GOVERNMENT OF MADRAS.
JUDICIAL DEPARTMENT.

on the subject of the type design for a Sub-Registrar's office.

Approving of the revised standard design for Sub-Registrar's office being substituted for that circulated with G.O., 14th January 1884, No. 100-W.

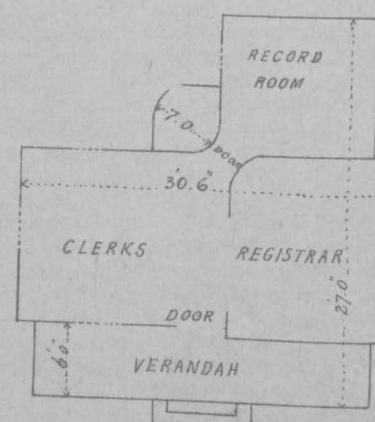
2. Government have lately from time to time approved of three type designs for a Sub-Registrar's office—one with a flat roof, one with a tiled roof, and the third with a tiled roof. The first two are on the same plan. The third is planned differently. Very many of the first two designs have been and are being built all over the Presidency and the Inspector-General informs me they answer their purpose well. Of the third design no building has as yet been erected. And to the plan of the third he objects on three chief grounds—one, that the record rooms are too small; secondly, that they do not open directly from the Sub-Registrar's own office; and, thirdly, that they are on different floors connected by a narrow staircase. The third design was drawn up by Mr. Chisholm (before proceeding on furlough) and was intended to be used only when registration offices are to be built in the same compound with cutcherries on the standard plan. It will cost Rs. 2,700 against Rs. 2,500 the cost of either of the two other designs. And this type design now under reference cannot be modified without enhancing this comparative increment in its cost. Moreover, as the other two type designs (both on the same plan) have been erected in large numbers and have proved to be satisfactory buildings suited to the requirements of the Registration department, I beg to suggest that a design be drawn up on that plan, so arranged in elevation as to harmonize with the taluk cutcherries alongside of which it may have to be built. This I shall be happy to do if required.

4. I beg, in conclusion, to append a sketch of the two plans showing their differences:—

New plan objected to by the Registrar-General.

Old plan which the Registrar-General prefers.

2. If approved in the Judicial department, it is proposed to have a revised type design, as suggested at the end of paragraph 2 of Lieutenant-Colonel Morant's letter, drawn up and published in supersession of the design circulated with G.O., dated 14th January 1884, No. 100-W.

The Government approve of the revised standard design referred to in the last two of the foregoing papers being substituted for that circulated with G.O., 14th January 1884, No. 100-W.

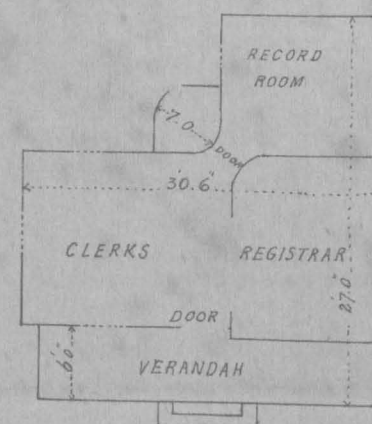
2. Government have lately from time to time approved of three type designs for a Sub-Registrar's office—one with a flat roof, one with a tiled roof, and the third with a tiled roof. The first two are on the same plan. The third is planned differently. Very many of the first two designs have been and are being built all over the Presidency and the Inspector-General informs me they answer their purpose well. Of the third design no building has as yet been erected. And to the plan of the third he objects on three chief grounds—one, that the record rooms are too small; secondly, that they do not open directly from the Sub-Registrar's own office; and, thirdly, that they are on different floors connected by a narrow staircase. The third design was drawn up by Mr. Chisholm (before proceeding on furlough) and was intended to be used only when registration offices are to be built in the same compound with cutcherries on the standard plan. It will cost Rs. 2,700 against Rs. 2,500 the cost of either of the two other designs. And this type design now under reference cannot be modified without enhancing this comparative increment in its cost. Moreover, as the other two type designs (both on the same plan) have been erected in large numbers and have proved to be satisfactory buildings suited to the requirements of the Registration department, I beg to suggest that a design be drawn up on that plan, so arranged in elevation as to harmonize with the taluk cutcherries alongside of which it may have to be built. This I shall be happy to do if required.

4. I beg, in conclusion, to append a sketch of the two plans showing their differences :—

New plan objected to by the Registrar-General.

Old plan which the Registrar-General prefers.

2. If approved in the Judicial department, it is proposed to have a revised type design, as suggested at the end of paragraph 2 of Lieutenant-Colonel Morant's letter, drawn up and published in supersession of the design circulated with G.O., dated 14th January 1884, No. 100-W.

The Government approve of the revised standard design referred to in the last two of the foregoing papers being substituted for that circulated with G.O., 14th January 1884, No. 100-W.

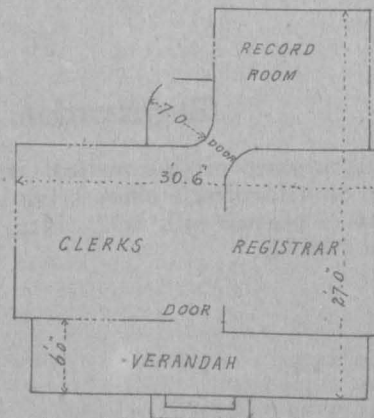
2. Government have lately from time to time approved of three type designs for
a Sub-Registrar's office—one with a flat roof, one with a tiled roof, and the third with
a tiled roof. The first two are on the same plan. The third is planned differently.
Very many of the first two designs have been and are being built all over the Presi-
dency and the Inspector-General informs me they answer their purpose well. Of the
third design no building has as yet been erected. And to the plan of the third he
objects on three chief grounds—one, that the record rooms are too small; secondly, that
they do not open directly from the Sub-Registrar's own office; and, thirdly, that they
are on different floors connected by a narrow staircase. The third design was drawn
up by Mr. Chisholm (before proceeding on furlough) and was intended to be used only
when registration offices are to be built in the same compound with cutcherries on

the standard plan. It will cost Rs. 2,700 against Rs. 2,500 the cost of either of the
two other designs. And this type design now under reference cannot be modified
without enhancing this comparative increment in its cost. Moreover, as the other two
type designs (both on the same plan) have been erected in large numbers and have
proved to be satisfactory buildings suited to the requirements of the Registration
department, I beg to suggest that a design be drawn up on that plan, so arranged in
elevation as to harmonize with the taluk cutcherries alongside of which it may have
to be built. This I shall be happy to do if required.

4. I beg, in conclusion, to append a sketch of the two plans showing their
differences:—

New plan objected to by the Registrar-General.

Old plan which the Registrar-General prefers.

2. If approved in the Judicial department, it is proposed to have a revised type design, as suggested at the end of paragraph 2 of Lieutenant-Colonel Morant's letter, drawn up and published in supersession of the design circulated with G.O., dated 14th January 1884, No. 100-W.

The Government approve of the revised standard design referred to in the last two of the foregoing papers being substituted for that circulated with G.O., 14th January 1884, No. 100-W.

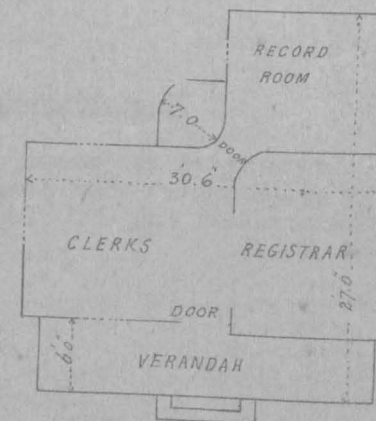
2. Government have lately from time to time approved of three type designs for
a Sub-Registrar's office—one with a flat roof, one with a tiled roof, and the third with
a tiled roof. The first two are on the same plan. The third is planned differently.
Very many of the first two designs have been and are being built all over the Presi-
dency and the Inspector-General informs me they answer their purpose well. Of the
third design no building has as yet been erected. And to the plan of the third he
objects on three chief grounds—one, that the record rooms are too small; secondly, that
they do not open directly from the Sub-Registrar's own office; and, thirdly, that they
are on different floors connected by a narrow staircase. The third design was drawn
up by Mr. Chisholm (before proceeding on furlough) and was intended to be used only
when registration offices are to be built in the same compound with cutcherries on

the standard plan. It will cost Rs. 2,700 against Rs. 2,500 the cost of either of the
two other designs. And this type design now under reference cannot be modified
without enhancing this comparative increment in its cost. Moreover, as the other two
type designs (both on the same plan) have been erected in large numbers and have
proved to be satisfactory buildings suited to the requirements of the Registration
department, I beg to suggest that a design be drawn up on that plan, so arranged in
elevation as to harmonize with the taluk cutcherries alongside of which it may have
to be built. This I shall be happy to do if required.

4. I beg, in conclusion, to append a sketch of the two plans showing their
differences :—

New plan objected to by the Registrar-General.

Old plan which the Registrar-General prefers.

2. If approved in the Judicial department, it is proposed to have a revised type design, as suggested at the end of paragraph 2 of Lieutenant-Colonel Morant's letter, drawn up and published in supersession of the design circulated with G.O., dated 14th January 1884, No. 100-W.

The Government approve of the revised standard design referred to in the last two of the foregoing papers being substituted for that circulated with G.O., 14th January 1884, No. 100-W.
